Access Compliance Report

Public Rights-of-Way

(Curb Ramps)

Intersection ID: 15243	Main Street: ALBEMARLE_RD	Cross Street: REGAL_OAKS_DR	Location: SE
ADA ID: 481378DEB48D	Ramp Type: Combination1Diag	Initial Pass/Fail: Fail	Overall Compliance: No
		Severity Score: 0

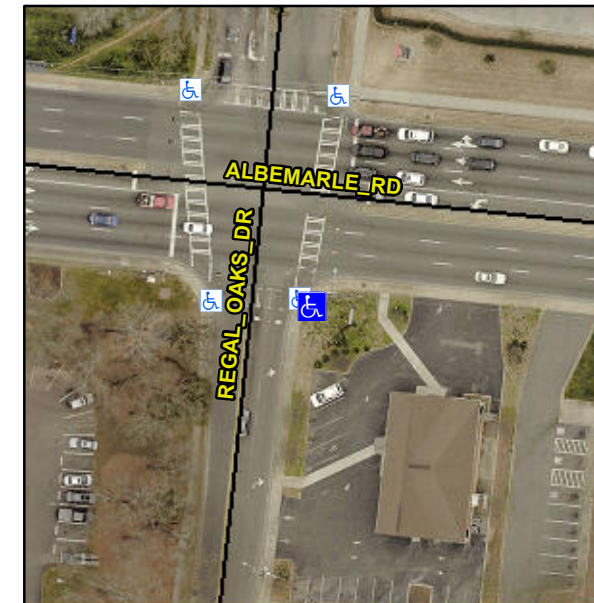
RP & RT RP < 5%

Not Found, R304.5.3, R304.3.2

Remove & Replace Curb Ramp With Two New Directional Ramps or Equivalent.
